# 3. STREETS + BUILDING PLOTS

#### 4.1 Tower setbacks

Haymarket Square with set back towers - as submitted for SSDA 2

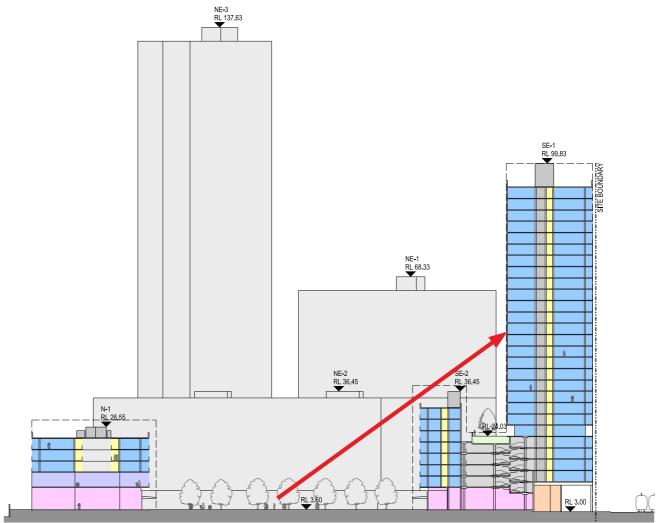
All towers (and their Maximum Building Envelopes) must be setback at least 5 metres from any podium edge at any point.

Building cores should be setback at least 5m from the street frontage.

The Concept Proposal proposes 'streets and buildings' rather than a 'tower and podia' composition of development.

The proposed towers are setback as far as possible from the new square to minimise overshadowing and to achieve an appropriate relationship of built form to public space.

The generous existing street widths of 30 metres on Harbour Street, Hay Street and Darling Drive are deemed to be appropriately broad streets in Sydney and able to accommodate hard edge, high rise development.

Illustrative Scheme partial section CC - as submitted for SSDA 2

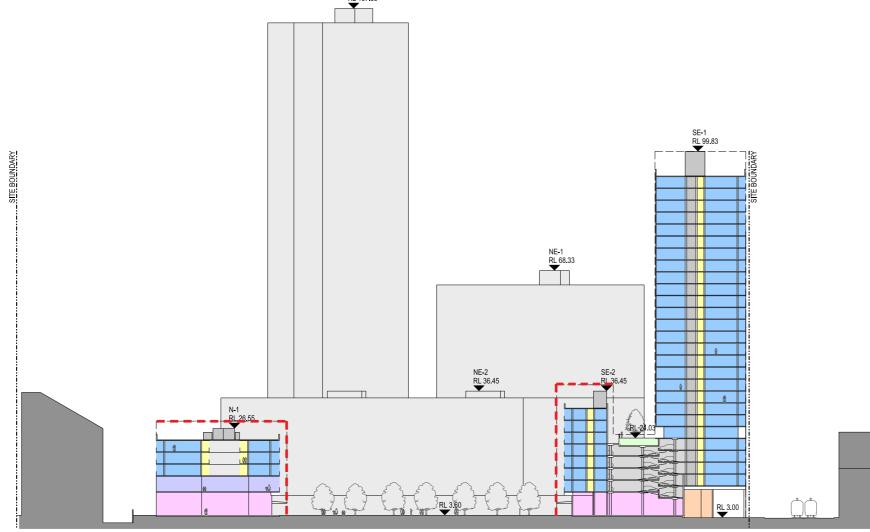
The podium heights surrounding the new square should be lowered in height with green roofs to improve winter sun access into the new square and potentially raised along the surrounding streets to rebalance floor area.

The north plot building should be reduced to four storeys to improve winter sun access into the new square.

The maximum building envelope proposed for the square edge allows for lift overruns and plant enclosure on the roof of these buildings.

The Illustrative Scheme indicates a parapet height lower than the current maximum building envelope with rooftop plant setback to minimise the visual impact.

This reduces overshadowing of The Boulevard and Haymarket Square and maximises the natural amenity of these new public spaces.

The N Plot building height needs to be sufficient to screen the Pier Street overpass from within Haymarket Square and to hold the western edge of the grand 20 metre Boulevard.

Shadow studies were provided within the SSDA 2 Design Report.

These were based upon the maximum building envelope to model the worst case scenario.

These studies show that there will be a good sunlight access to parts of the Haymarket Square and The Boulevard throughout the year.

Cross section through Powerhouse Museum and DD + SW Plots within Concept Proposal (sc 1:750@ A3)

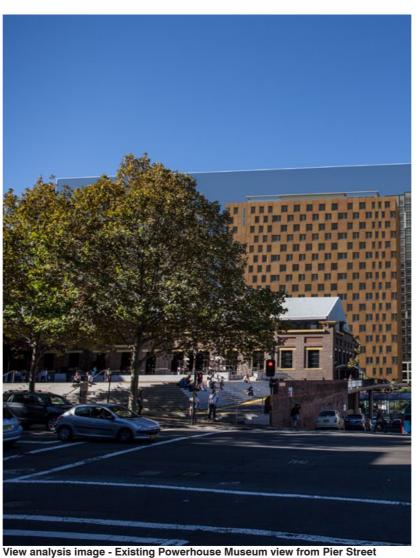
It is recommended that the student housing tower(s) be shaped in plan at the northern end and reduced in height so as to avoid overshadowing of the rear publicly accessible courtyard of the Powerhouse Museum in winter and to avoid the appearance of a high visual barrier to Ultimo/Pyrmont.

The maximum building envelope proposed under the Concept Proposal DA (SSDA 2) allows for lift overruns and rooftop plant.

The plan constraints require increased building height to enable the student accommodation to achieve a critical mass, important in establishing a student precinct along Darling Drive.

The scale of the student accommodation is consistent with that proposed for The Haymarket buildings. The twenty (20) stories is in keeping with the scale of other new residential developments which are proposed for the local area.

The Illustrative Scheme reduces the building height on the northern building to reduce the impact of overshadowing of the Powerhouse Museum courtyard garden. This massing will be confirmed during the Stage 2 Development Application

Diagram showing alignment and visual connectivity to Powerhouse Museum

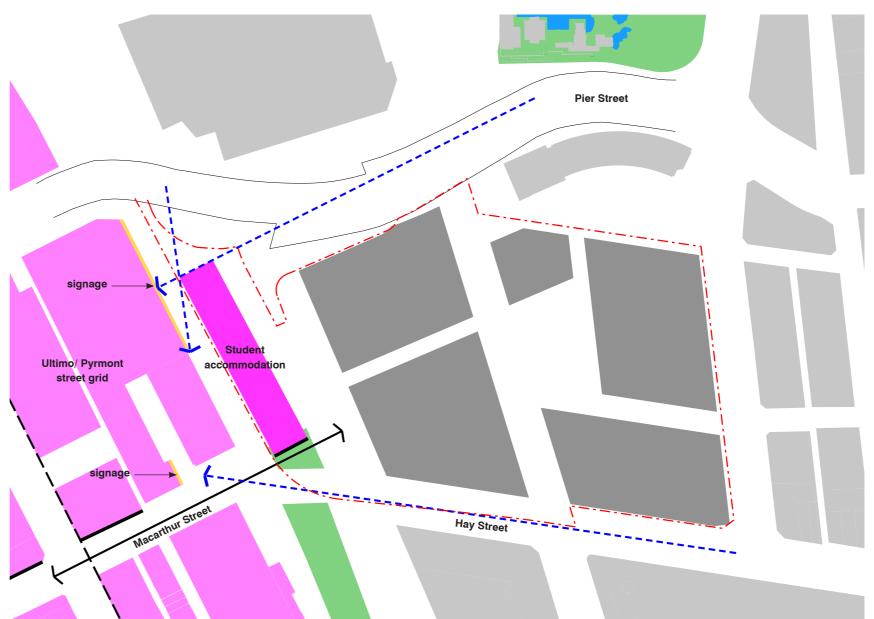
The Macarthur Street view corridor to the city should be respected by the deletion of the western tower within the SW Plot.

Macarthur Street is not an identified or nominated view corridor or public domain vista or vantage point in any planning controls or guidelines.

The development proposed by The Haymarket Concept Proposal, including proposed Building W2 will enclose or terminate the public domain view from this vantage point with new buildings.

The Concept Proposal maximum building envelope proposed under The Haymarket SSDA2 has sought to provide for the establishment of 'gaps' to sky between the building forms in The Haymarket when looking in this direction.

This analysis considers the Macarthur Street views in detail and concludes that "notwithstanding the change to the CBD skyline that will inevitably result, it is considered that the proposed Residential (Student Accommodation) Building W2 will not obstruct any significant public domain views and will result in no loss or detraction from the significant aspects or aesthetics of existing public domain views in the locality."

Visual connectivity along Little Hay Street

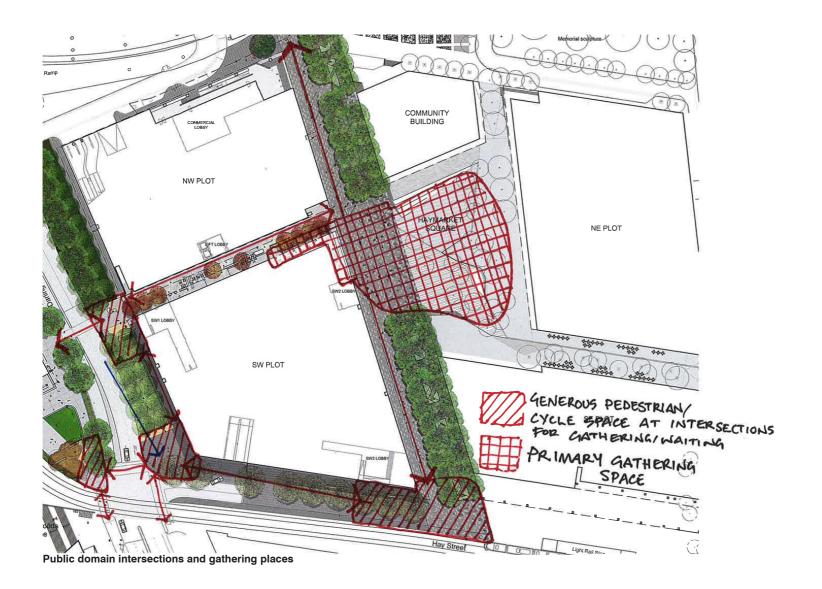
Chamfers should be provided on all corners for 2.5 metres in either direction to improve visual safety and meet Crime Prevention through Environmental Design (CPTED) principles.

The northern corner of the South-West Plot should be chamfered to enable a clear view into Dickson's Lane from the Boulevard.

Chamfered corners are usually adopted within dense, tight and congested urban settings where there are high footfalls and occasion for people to linger.

Corners to lanes and streets are either fully glazed retail shopfronts or residential lobbies which allow for full visual safety to the 2.5 metres required and in most cases provide a wider field of view.

Compared to the existing condition the new thoroughfares are at-grade, generously proportioned and travel across active and occupied spaces and provide a direct line-of-sight to connecting streets and squares.
